Aviation Rulemaking Advisory Committee; Transport Airplane and  
Engine Issues--New Tasks

To: Aviation Rulemaking Advisory Committee -  
Transport Airplane and Engine Interest Group (TAEIG)

In accordance with the 4 June 1999 Better Plan for Harmonization, PPIHWG submits Attachment 1 through 11 related to harmonization of FAR/JAR 25.903(e) – Inflight starting.

### **ENGINE RESTART CAPABILITY DEMONSTRATION FOR TRANSPORT CATEGORY AIRPLANES**

Chart 1

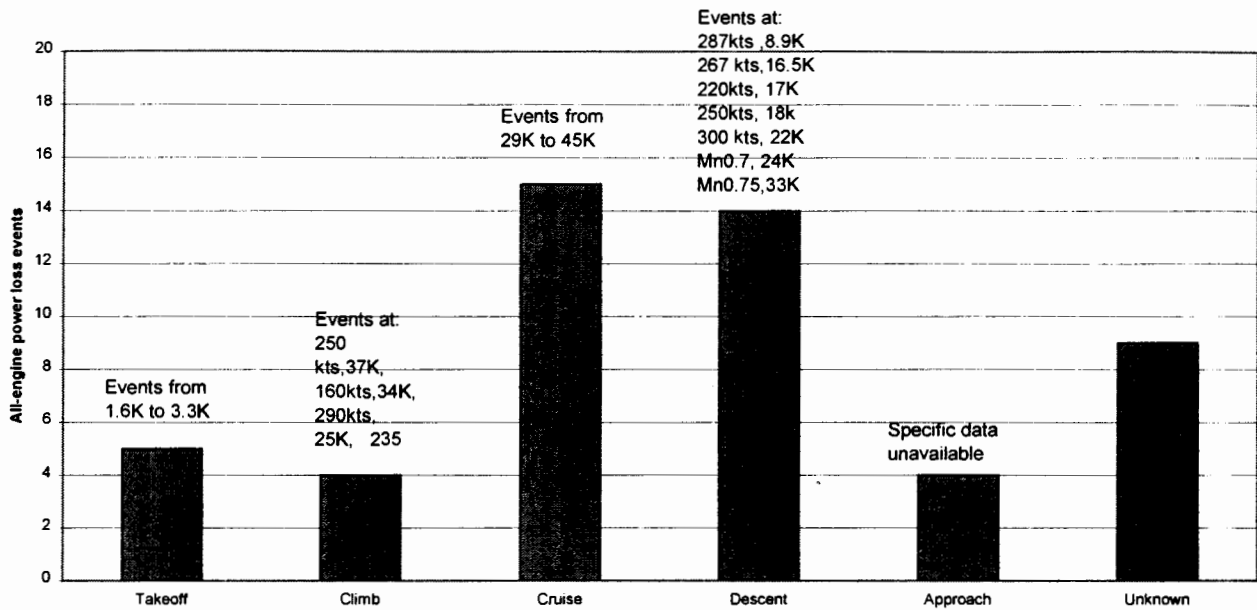
Since this advisory material is introduced “to maintain the current level of safety” (section 4.3), the conditions to be demonstrated should be within the capability of the majority (50%) of the existing fleet. It is not possible to establish from existing data whether the majority of the existing fleet could meet section 7, condition 1 (high power fuel cut and recovery within 2500 ft), but the limited information available suggests that most of the fleet could not demonstrate this condition. The alternate means of compliance proposed above (A) may provide some relief. It is proposed that the wording of section 7, condition 1 be changed as follows:

Chart 3 shows the minimum windmill start airspeed as a function of aircraft certification date. Half of the engine/airframe combinations currently in service are capable of windmill start, S/L, at 250 knots. Therefore a reasonable criterion for maintaining the current safety standard would be 250 knots rather than 1.45 V<sub>stall</sub>. The following wording change is proposed to Section 7, condition 4:

The initial airplane speed that should be used for the all-engine out restart evaluation is **250 kts**. Acceptable means of compliance include rapid relight, starter assistance from an external source and stabilized windmill start. The airplane should not lose more than 5000 feet altitude between initiating restart procedures and achieving level flight.

**CHART 2**  
**Commercial Transport Fleet All-Engine Power Loss Events, by Flight Phase**  
**1960-1996**

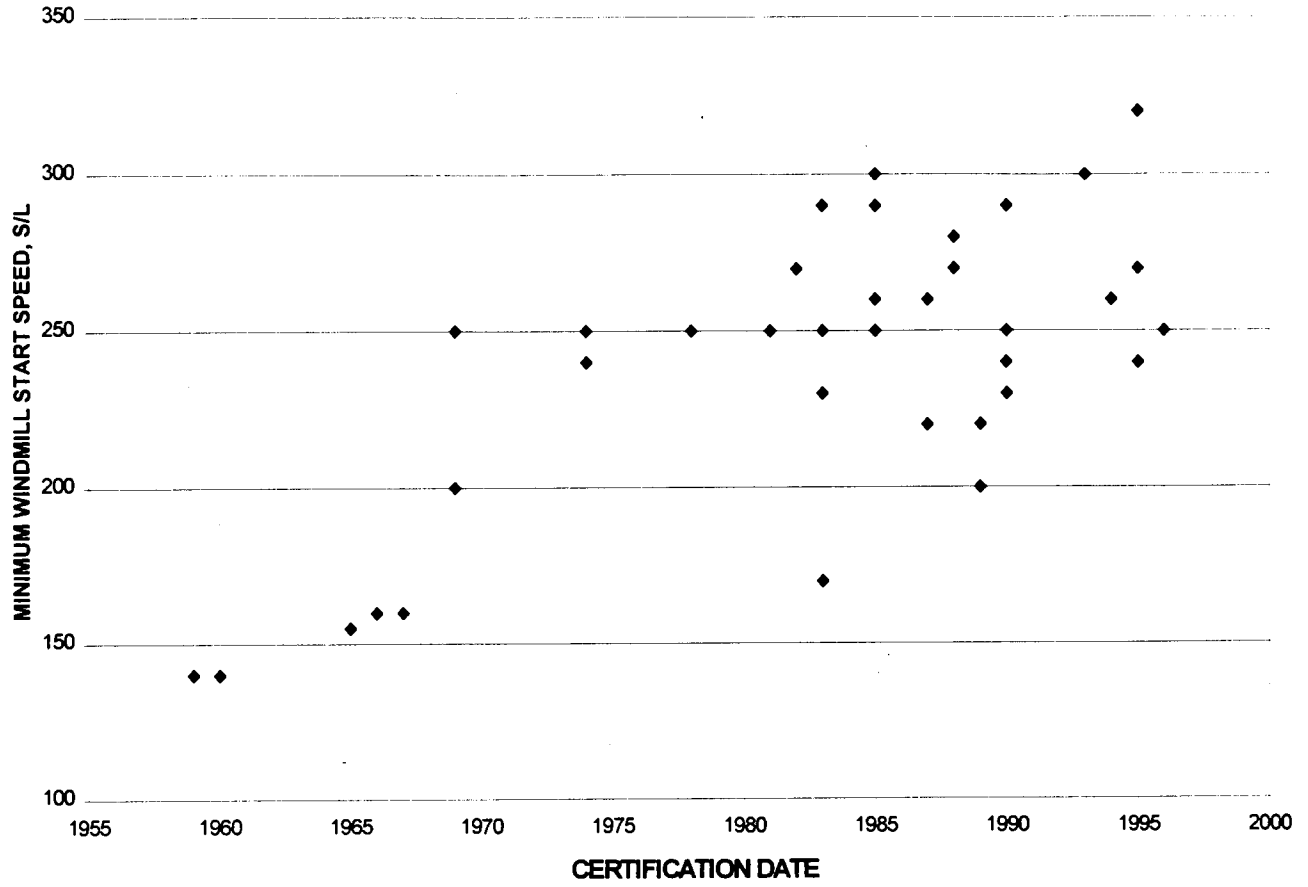
**Majority of events occur at high/intermediate altitudes. Low altitude/low airspeed/low power scenario (condition 4) represents no events/ a very small proportion of events**
